**From:** Larry Teahon <Larry\_Teahon@cameco.com>  
**Sent:** Tuesday, April 28, 2015 1:14 PM  
**To:** Lancaster, Thomas  
**Cc:** Doug Pavlick; Robert Tiensvold; Sabrina Fox; Larry McGonagle  
**Subject:** MET Data RAI #2  
**Attachments:** Table 2.5-14 Marsland MET Station Description Rev 1.pdf

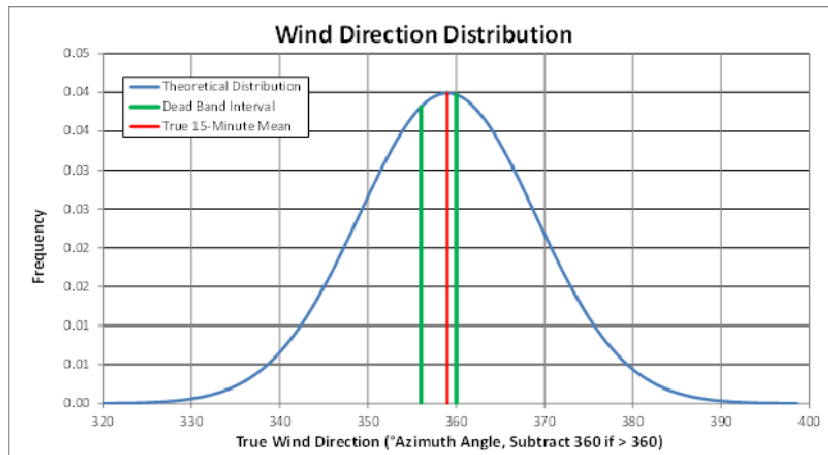
1. The height above ground level that wind speed, wind direction, temperature and relative humidity measurements are made;
2. A drawing or photograph of the meteorological tower showing the instrumentation location relative to the tower lattice work, including the lengths of the booms;
3. An evaluation which would establish that the wind sensor electrical range limitation to 356 degrees azimuth does not affect meteorological data fidelity.

Probability theory can be used to analyze the expected degree of bias in recorded wind directions. While the maximum instantaneous bias would be -4° based on the above description (i.e., when the true wind direction is just below 360°), the maximum average bias during the data logging interval is much closer to zero. The reason is that the wind direction fluctuates naturally throughout the logging interval. This fluctuation is quantified as sigma theta. Typically, the logger scan rate is every 1 to 5 seconds but the scanned directions are vector averaged over each logging interval (e.g., 15 minutes or 1 hour). Only the averaged directions are recorded. Shown below are a typical dead band interval, hypothetical 15-minute mean wind direction of 359°, and overall data distribution during this logging interval based on a sigma theta of 10°.

In the northern Great Plains, typical 15-minute values for sigma theta range from 5° to 20° and higher. This means that even when the true 15-minute average wind direction falls within the instrument dead band, the instantaneous wind direction will statistically fall outside the dead band for most of the logging interval. During these times the sensor will indicate the correct wind direction (subject to instrument accuracy), thus lowering the overall average bias in the wind direction signal. Using the example graphed above, if the true 15-minute average is 359°, sigma theta is 10°, and wind directions are normally distributed, the sensor will read full scale less than 16% of the time. While at full scale, the expected average sensor error is -2.02°. Therefore, the average bias throughout the 15-minute interval is  $0.16 \times -2.02 = -0.32^\circ$ .

Sigma theta is the standard deviation of the horizontal wind direction values scanned during the logging interval. Even when the 15-minute average wind direction falls outside the instrument dead band, some error may be introduced due to this standard deviation in wind directions. Higher sigma theta values will lead to lower peak errors, but with more dispersion as shown in the graphic below.
